SAFETY RECALL NOTICE

WORKHORSE CUSTOM CHASSIS SERVICE BULLETIN

BULLETIN NO: 20601-C

SUBJECT: Steering Intermediate Shaft

Inspection Procedure

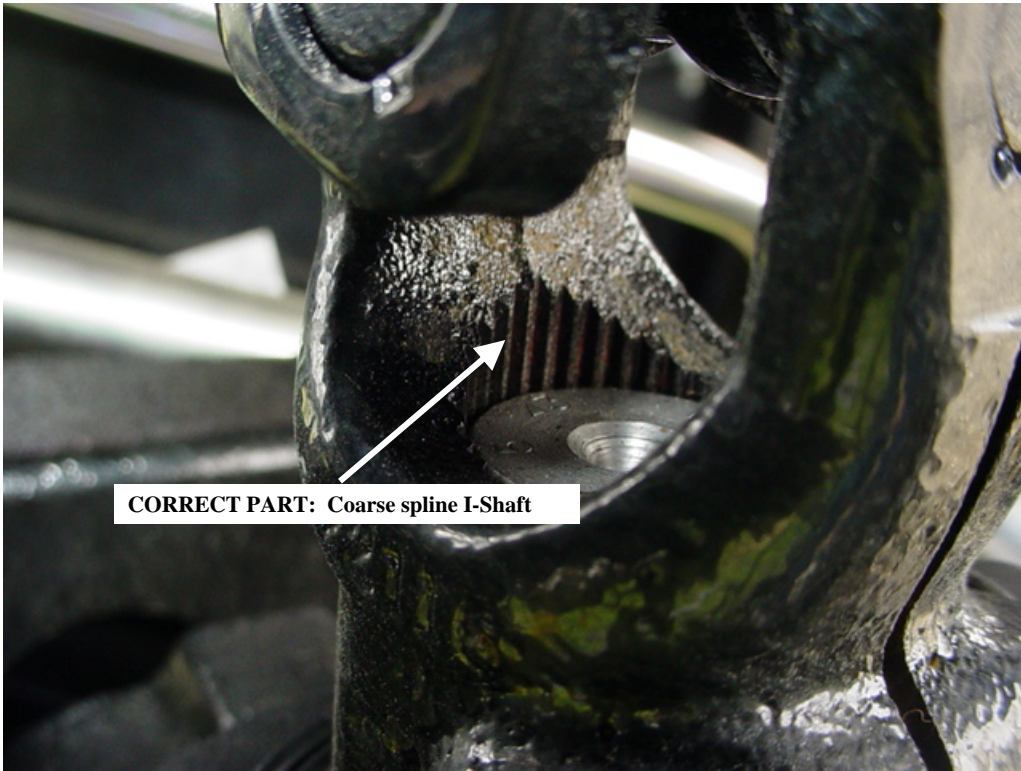
The below procedure should be used to determine if the correct steering intermediate shaft has been installed on the vehicle.

CORRECT PART: Coarse spline I-Shaft

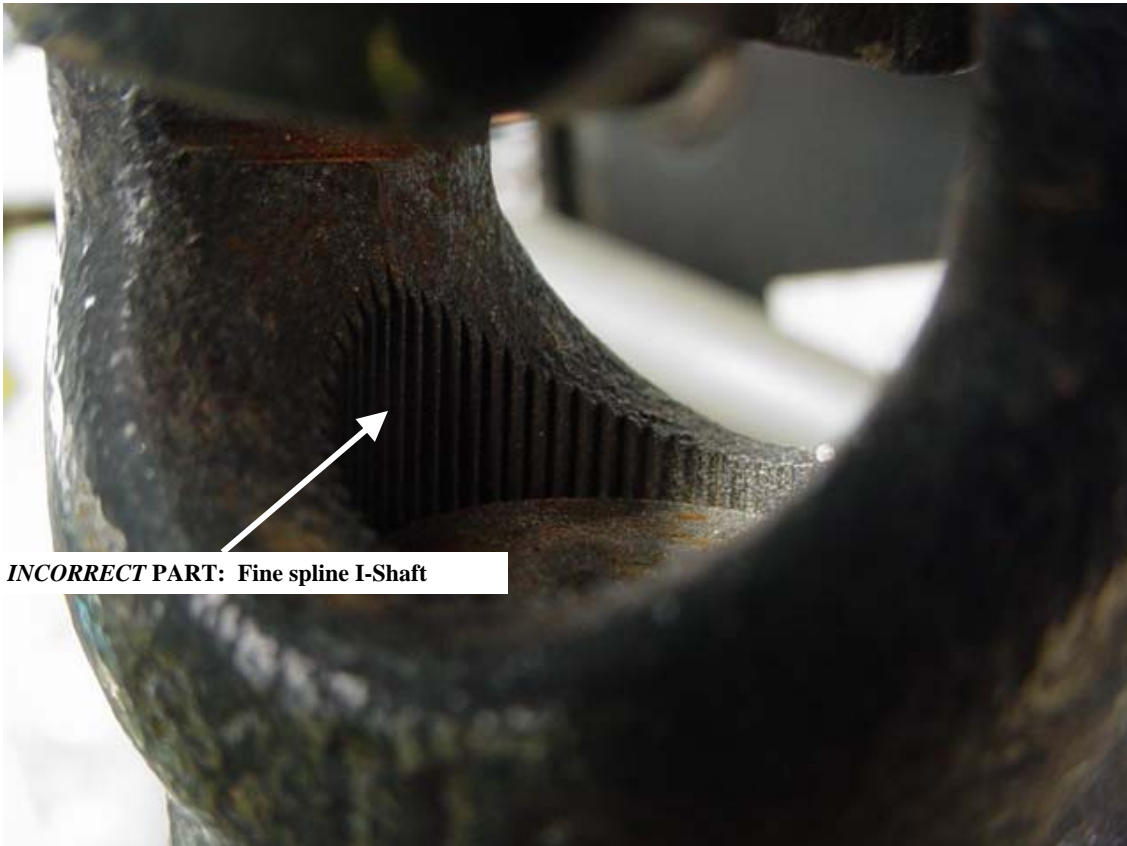
Inspect the intermediate shaft where it is connected to the input shaft at the top of the steering gear. The spline on the intermediate shaft is visible above the tip of the steering gear input shaft, as indicated in the photograph below:

The coarse spline I-shaft is shown above. This is correct for W20/22/24 models.

INCORRECT PART: Fine spline I-Shaft

The fine spline I-shaft is shown above. This is *incorrect* for W20/22/24 models.

The service procedure for this recall requires inspection of the steering intermediate shaft to determine if the correct part was installed (as shown in the attached Inspection Procedure). If an incorrect shaft is identified, it should be replaced with the correct part (Part Number W0000450). Torque pinch bolt to 36-40 ft-lbs.
